Cab Mounted Exhaust Bracket, Replacement GU

FSB 261-038, Cab Mounted Exhaust Bracket, Replacement

(May 2016)

W2037578

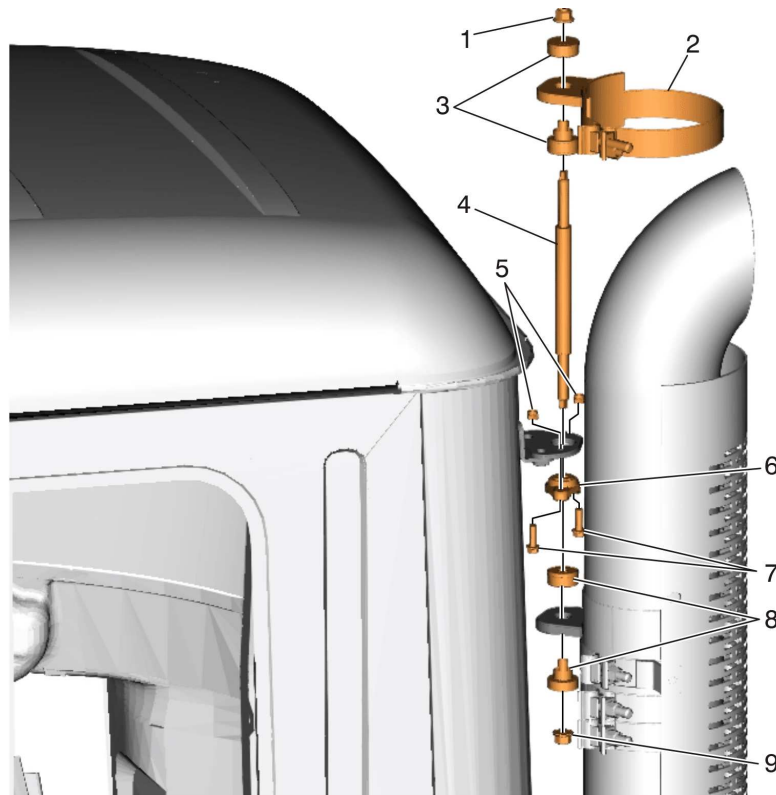
GU MACK models equipped with cab mounted exhaust may experience excessive engine noise or vibration in the cab. In most cases, this is caused by a worn bushing in the cab mounted exhaust bracket. The bushing size has been increased to extend the life of the bushing.

- 22817713 — Pivot Bracket

- 1 Secure the vehicle for service by parking it on a flat level surface, applying the parking brake, chocking the rear wheels, and placing the transmission in neutral or park.
- 2 Remove the fasteners securing the rubber mount isolator rod at upper stack mount.
- 3 Remove the upper mounting strap and rubber mount. (Loosen top clamp, slide clamp up pipe and off isolator rod.)
- 4 Remove the rubber mount isolator rod from the spherical bearing.
- 5 Remove the spherical bearing from the mounting bracket.
- 6 Remove the rubber mounts from the upper and lower strap mounts.
- 7 Install the rubber mounts in the upper and lower strap mounts.
- 8 Install spherical bearing.

Note: Do not lubricate bearing pin. The spherical bearing is self-lubricating and does not require additional lubricant.

- 9 Install the rubber mount isolator rod and upper mounting strap.
- 10 Tighten the mounting fasteners for rubber mount isolator rod and tighten the mounting strap.
- 11 Start the engine and check for leaks.
